CONSULTANT ADVICE NOTICE

Project: Monaro Cluster - Hindmarsh

CAN No: G-003[1.4]

Reference is made to the response submissions from the Department of Planning, Industry and Environment (DPIE), - Queanbeyan-Palerang Regional Council and Transport for NSW (TfNSW) with respect to SSDA submission for the New High School in Jerrabomberra (Reference SSD – 24461956).

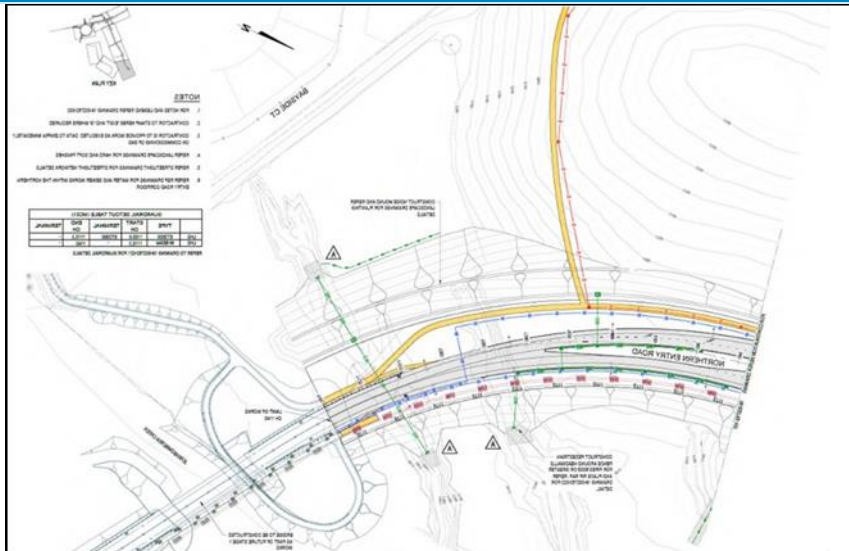
QPRC Submissions		
No	Item	Request
2	<p>Utilities</p> <p>Further definition and coordination of water services required with Council</p>	Refer to response to 2.2
2.1	<p><u>Comments</u></p> <p>The main Council facilities impacted by the development are shown in the extract image below.</p> <ul style="list-style-type: none"> • Red – Sewer “S” • Blue – Water “W” • Green – Stormwater “SW” 	Refer to response to 2.2

HYDRAULIC SERVICES - SITE PLAN -
ZONE 1

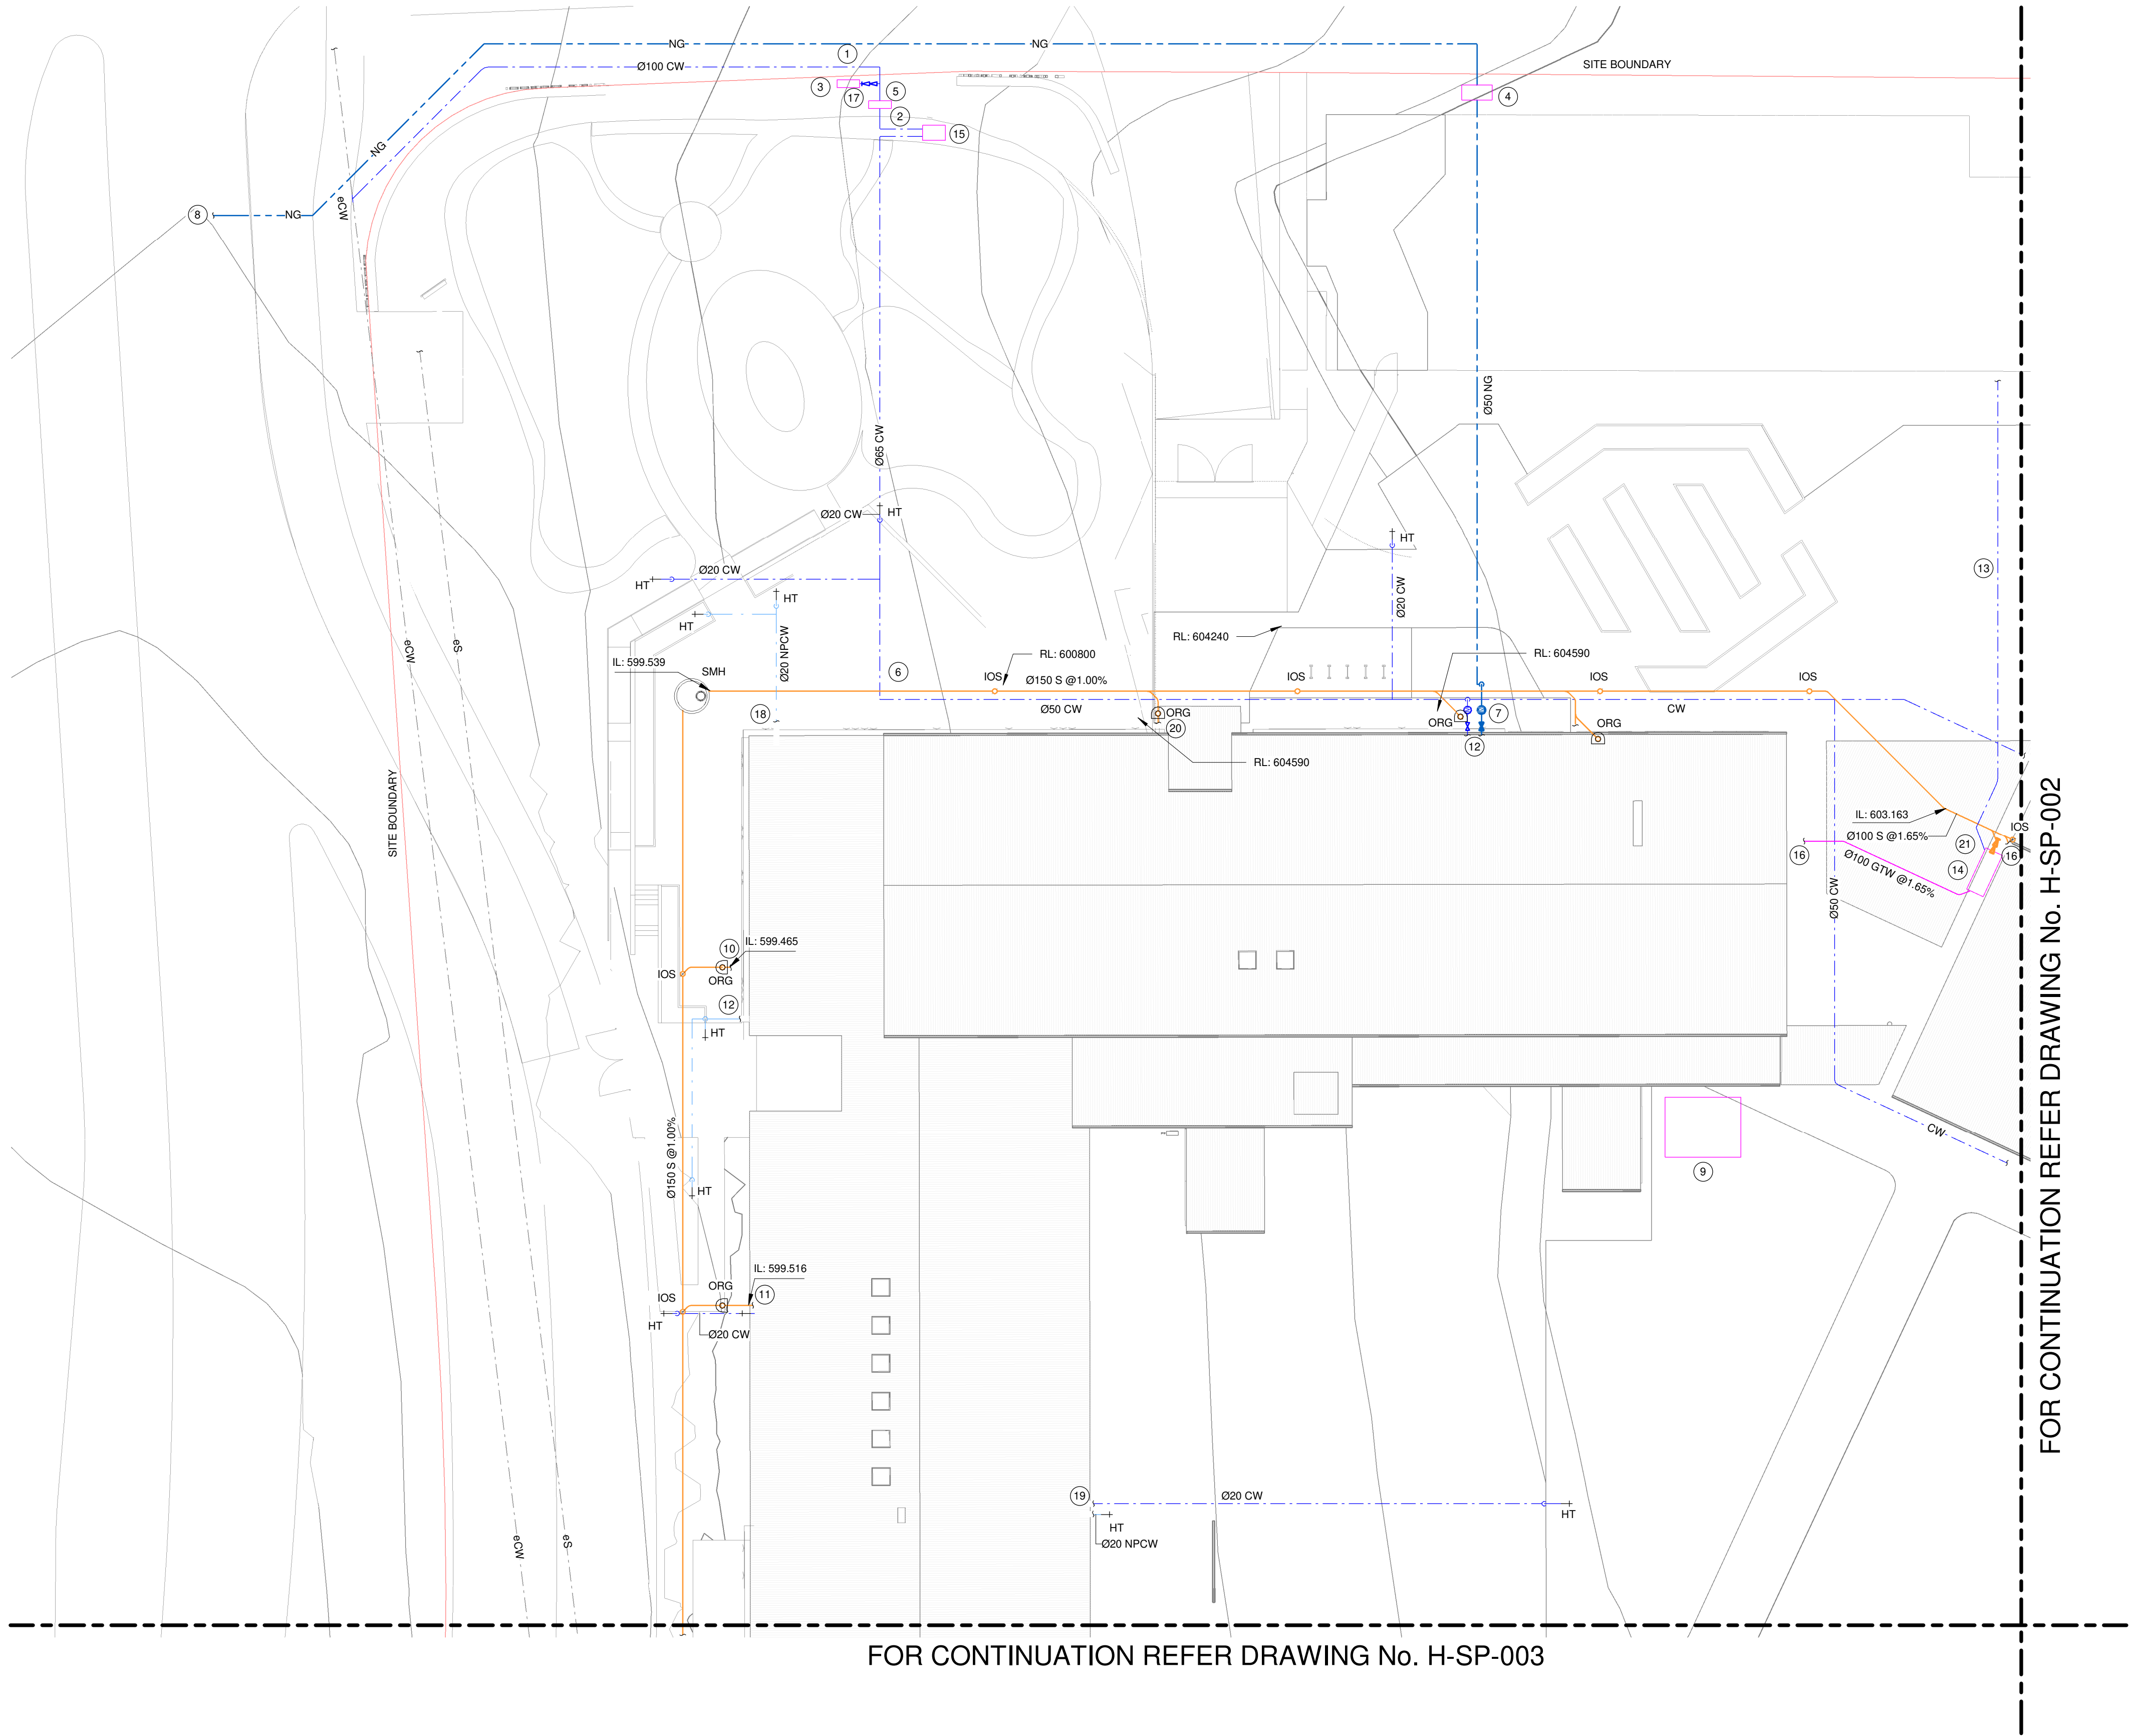
QPRC Submissions		
2.2	<p><u>Recommendations</u></p> <p>That the consent authority impose conditions requiring:</p> <ul style="list-style-type: none">• Preparation of a hydraulic design plan providing details of the required sizing for all water, sewer and stormwater services required for the site.• The preparation of an on-site detention design to limit stormwater discharge from the site to pre-development flows. <p>That all connections and alterations to Council's utility services are inspected by Council staff prior to backfilling.</p>	<p>As part of NDY's phase 4 design packages, a hydraulics services site plan (as recommended by Council) was detailed which highlights the location and sizing for the water and sewer services for the site (note: below-ground stormwater is contained within the civil engineering package). The hydraulic services site plan has been appended to this CAN in Appendix C.</p>
